Access Compliance Report

Public Rights-of-Way

(Curb Ramps)

Intersection ID: N/A	Main Street: PROVIDENCE COUNTRY CLUB DR	Cross Street: WAVERLY WALK AV	Location: SW
ADA ID: C4AF95630EB0	Ramp Type: Directional	Initial Pass/Fail: Fail	Overall Compliance: No
			Severity Score: 13.75

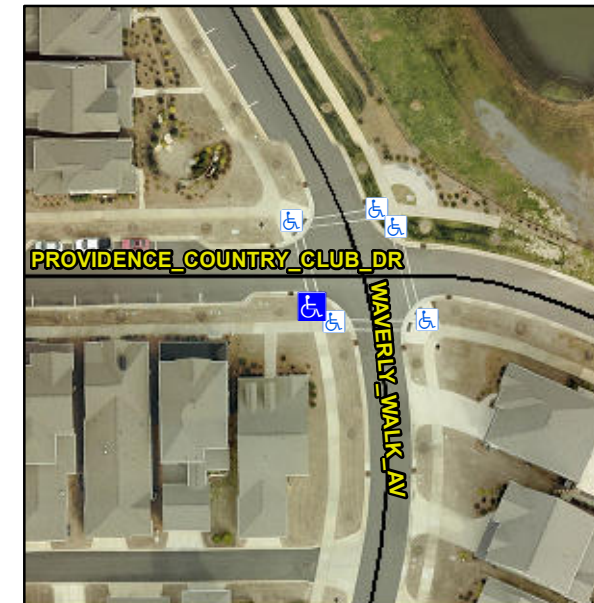
R304.2.2, R304.5.3

Compliance	Description	Data	Compliance	Description	Data
N/A	Ramp Length (in)	128.0	N/A	Grade Break?	N/A
Yes	Ramp Width (in)	63.0	N/A	Grade Break Slope (%)	0.0
No	Ramp Slope (%)	8.5	N/A	Grade Break XSlope (%)	0.0
No	Ramp XSlope (%)	2.5			
N/A	Flare Type LT	N/A	N/A	Flare Type RT	N/A
N/A	Flare Slope LT (%)	N/A	N/A	Flare Slope RT (%)	0.0
N/A	Flare Traversable LT?	N/A	N/A	Flare Traversable RT?	N/A
N/A	Landing Length (in)	0.0	N/A	DWS Provided?	N/A
N/A	Landing Width (in)	0.0	N/A	DWS Contrast?	N/A
N/A	Landing Slope (%)	0.0	N/A	DWS Length (in)	N/A
N/A	Landing X Slope (%)	0.0	N/A	DWS Full Width?	N/A
N/A	Landing Curb? (Y/N)	N/A	N/A	DWS Offset LT (in)	N/A
N/A	Shared Landing?	N/A	N/A	DWS Offset RT (in)	N/A
N/A	Gutter Ponding?	0.0	N/A	Gutter Slope (%)	N/A
N/A	Gutter Lip Ht (in)	0.0	N/A	Gutter X Slope (%)	N/A
N/A	Painted X Walk1?	No		Road Slope (%)	1.2
	X Walk 1 Direction	To NW		Road X Slope (%)	0.1
	X Walk 1 Width (in)	N/A		Clear Space?	N/A

Remove & Replace Entire Ramp.
